Japan Comments for Battery Durability GTR EVE42

JAPAN comments for EVE-41-05x GTR after drafting meeting

Table 1: Battery Energy based MPR

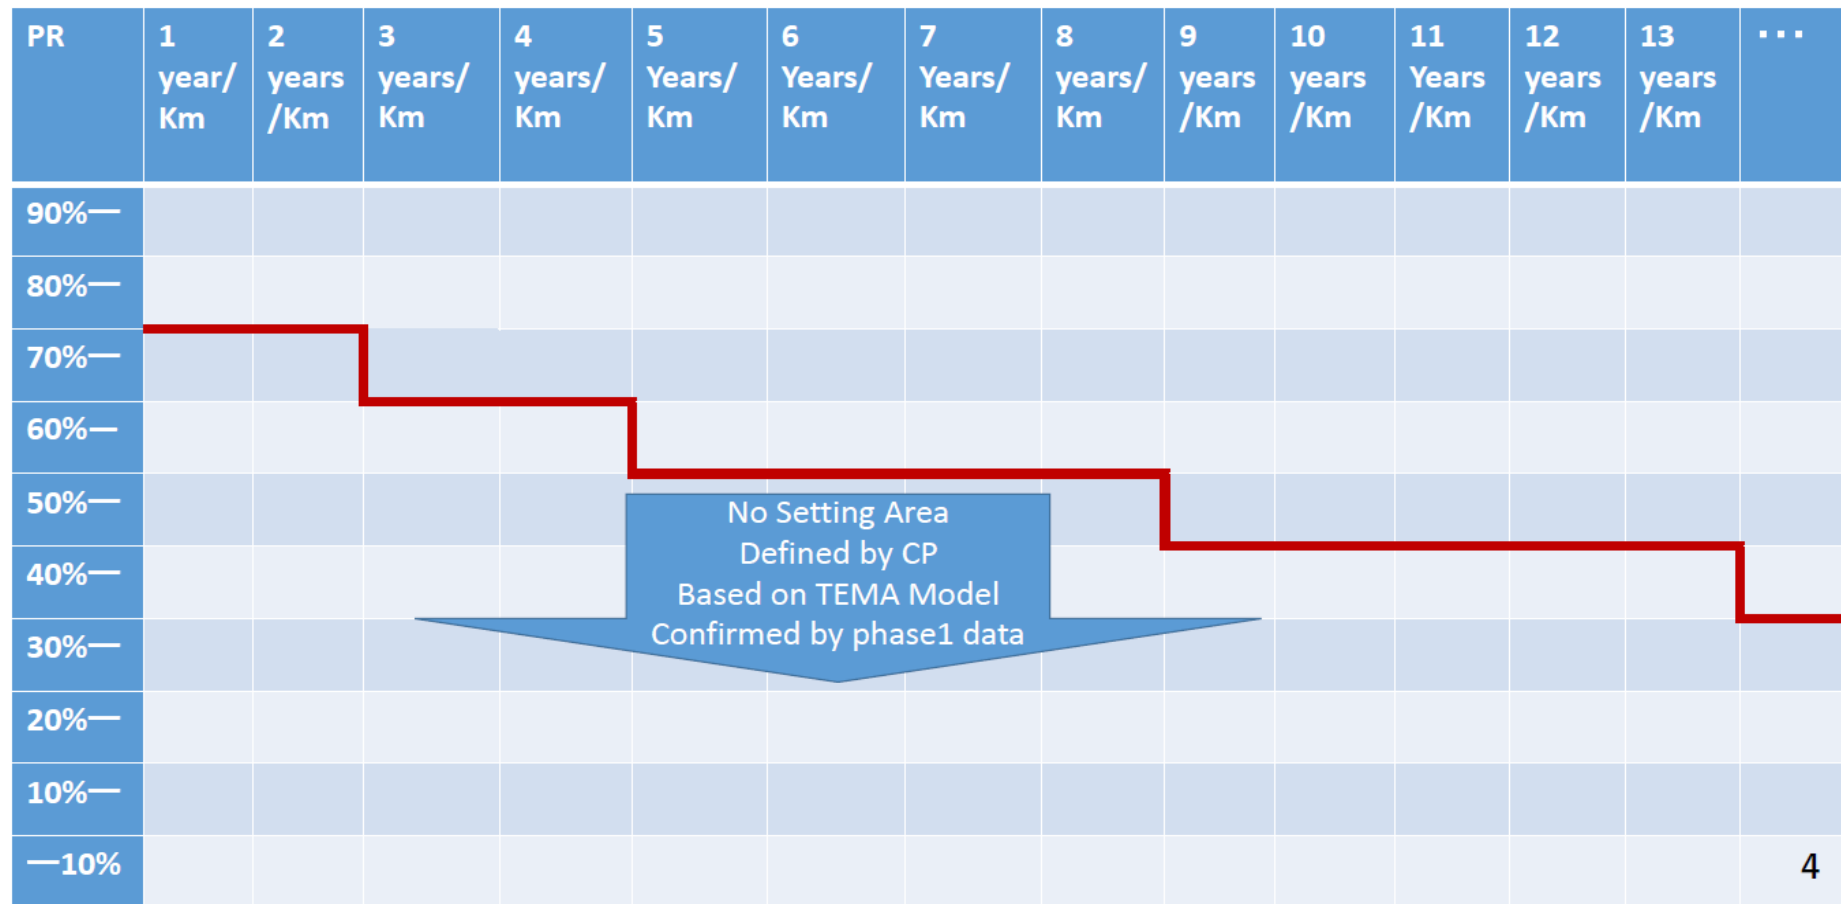
Japan understands that this table doesn't mean CPs need to define both 5- and 8-year MPR and that CPs may exempt the one of the useful life requirements.

In addition, Japan believes "5- and 8-years" here means each maximum period (harmonic consideration), e.g., MPR values for 8-years can be used at 7 years, according to inspection periods in each CP.
